**Correspondence Between  
Staff and Applicant**

**Case Reference No: 24-DR-2015 SkySong Restaurant**

RE: SkySong Restaurants Building - Scottsdale Case No. 24-DR-2015  
Response to 2<sup>nd</sup> Review Comments Dated August 12, 2015

RE: SkySong Restaurants Building - Scottsdale Case No. 24-DR-2015  
Response to 1<sup>st</sup> Review Comments Dated June 11, 2015

1 SITE PLAN WORKSHEET  
SCALE: 1" = 80'-0"

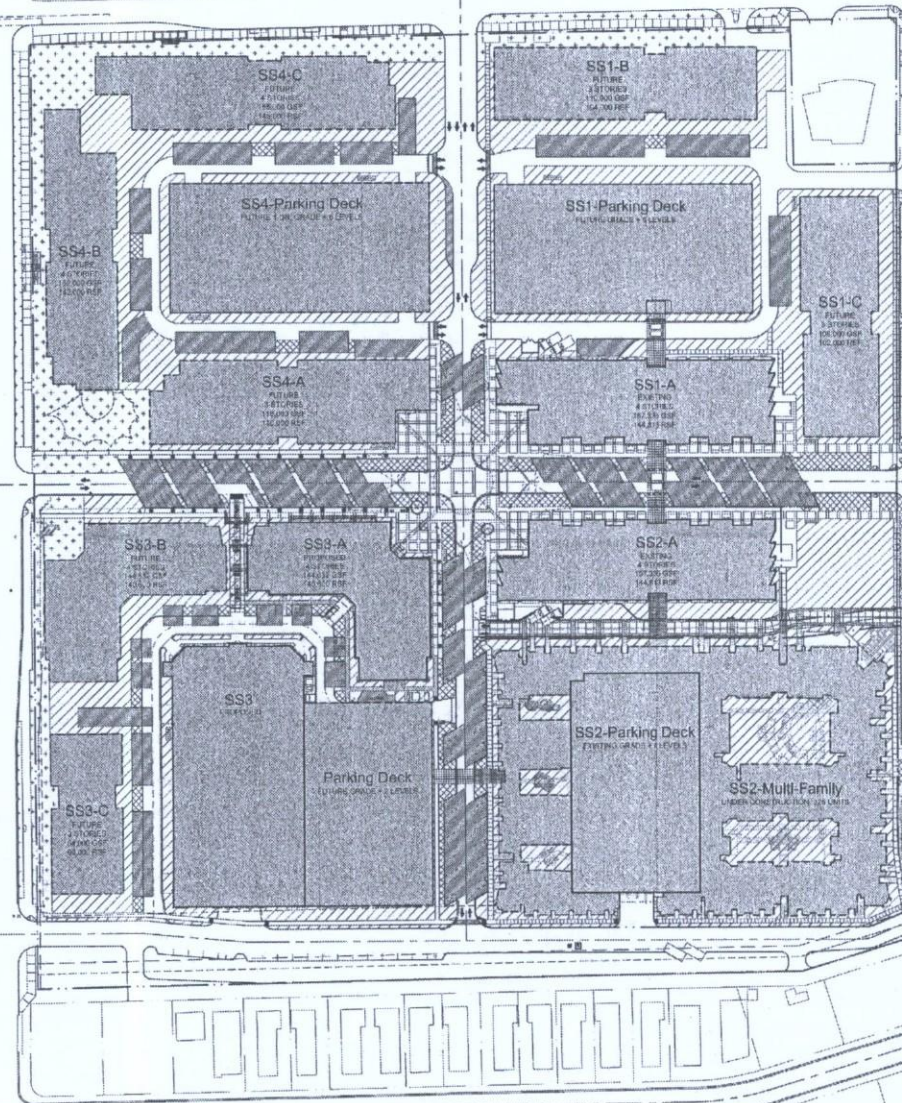
1. Regarding comment #3 from the 1<sup>st</sup> review letter – It appears that the open space requirements used on the site plan worksheet do not correspond with the requirements that were approved with the Skysong zoning. Per the amended standards, a minimum of 20% of the site shall be open space (increasing if building heights go above 90'). The submitted worksheet uses a 10% base with an additional amount based on heights above 10'. Please revise these calculations to correspond with the correct requirements.

The open space requirements on the revised site plan worksheet and open space plan included the resubmittal packet have been revised to correspond with the correct requirements.
